DEVELOPMENT APPLICATION ASSESSMENT REPORT

Application Number:	DA2020/0039
----------------------------	-------------

Responsible Officer:	Georgia Quinn
Land to be developed (Address):	Lot 339 DP 12316, 17 Kimo Street NORTH BALGOWLAH NSW 2093
Proposed Development:	Alterations and additions to a dwelling house
Zoning:	Warringah LEP2011 - Land zoned R2 Low Density Residential
Development Permissible:	Yes
Existing Use Rights:	No
Consent Authority:	Northern Beaches Council
Land and Environment Court Action:	No
Owner:	Christopher Patrick Raper Emily Mary Jane Newman
Applicant:	Christopher Patrick Raper Emily Mary Jane Newman

Figure 1. Building envelope non-compliance shown in pink.

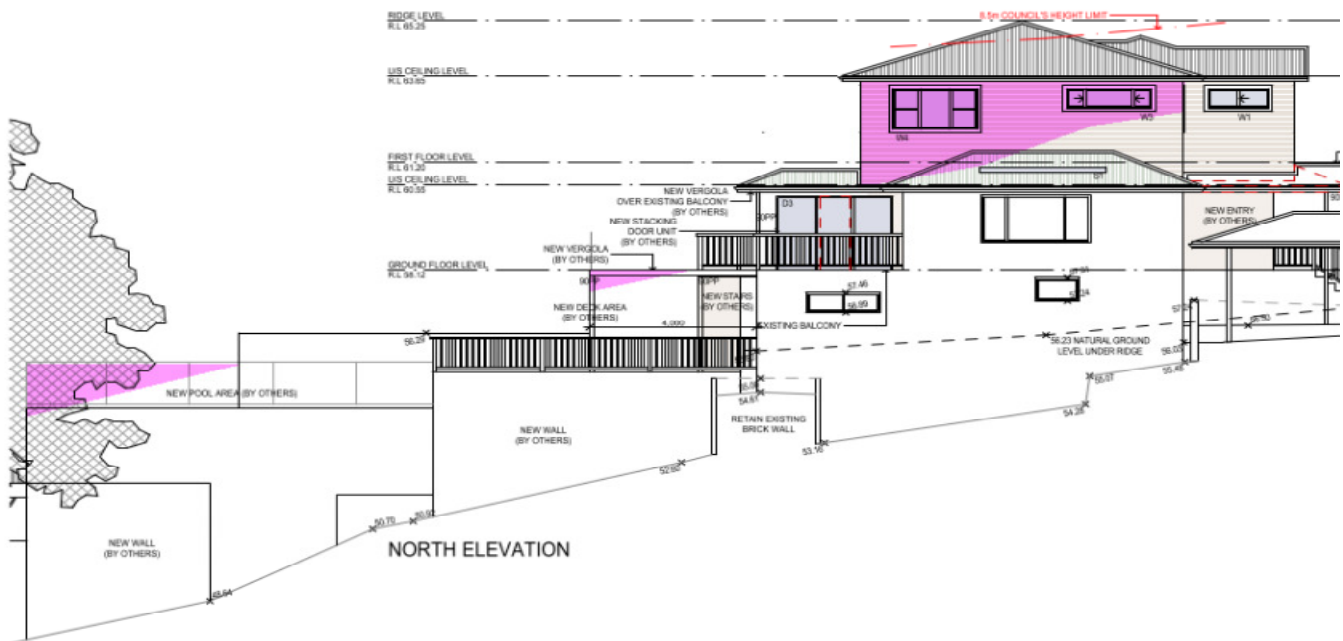
The northern elevation of the first floor addition encroaches beyond the prescribed 4m side boundary envelope by between 0.8 and 2.9m in height for a length of 7.8m, which represents a variation of up to 40.6%. The northern elevation of the pool encroaches beyond the envelope by between nil and 1.5m in height for a length of 5.1m, which represents a variation of up to 23.4%. The vergola also encroaches beyond the envelope for a length 2.3m. Figure 1 below demonstrates the aforementioned breaches.

The southern elevation of the first floor addition encroaches beyond the prescribed envelope by between 0.7 and 1.2m in height for a length of 5.4m as well as a secondary breach toward the rear portion of the addition by between nil and 0.2m in height for a length of 2.4m. Figure 2 below demonstrates such breaches.

gradient of the subject site in conjunction with the existing building. The greatest degree of the breach occurs along the northern elevation towards the rear of the building and considering the lower properties are situated to the north and east of the subject site, no unreasonable impact upon solar access will occur. Further, the application is supported with certified shadow diagrams (drawing numbers 9279 DA1 titled Site Analysis and Shadow Diagrams) which denote compliance with the solar access requirements of WDCP.
